### ADDENDUM No. 5

REQUEST FOR QUOTATIONS No.:	1220-040-2024-085
TITLE:	Fire Hall #1 and #2 Dorm Renovations
ADDENDUM ISSUE DATE:	December 12, 2024
DATE:	PREFER TO RECEIVE SUBMISSION ON OR BEFORE DECEMBER 19, 2024

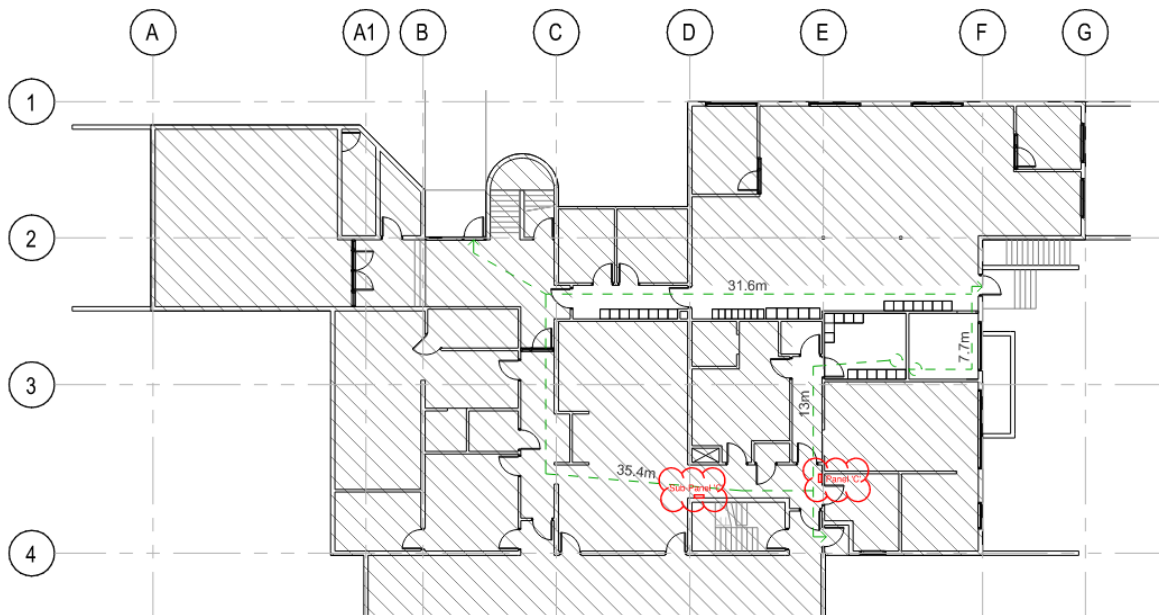
- Q1.** Can we get clarification on the location of Panel C and the data patch panel in the FH-1 building?
- A1.** Please see image on next page for location, and coordinate with City of Surrey on where to connect the new data runs.

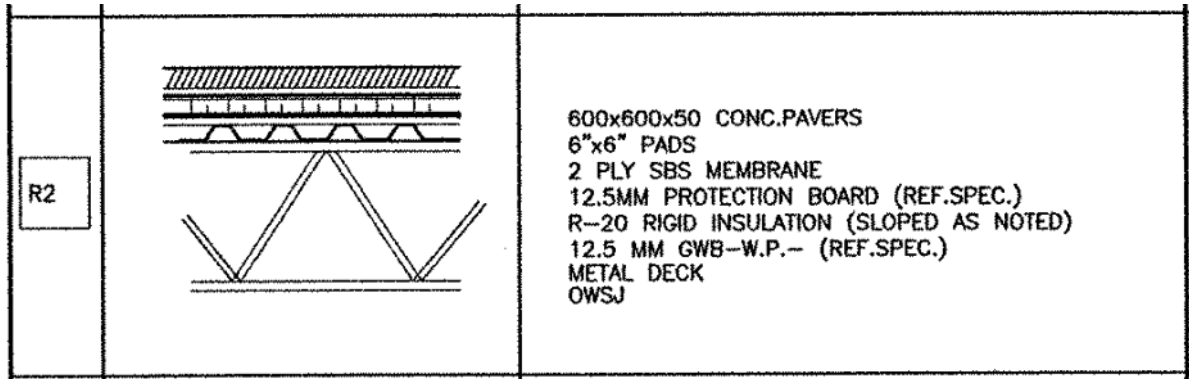
**Q5.** Does the roof have a steel, wood, or concrete deck?

**A5.** As per existing drawings the roof assembly is as indicated below:
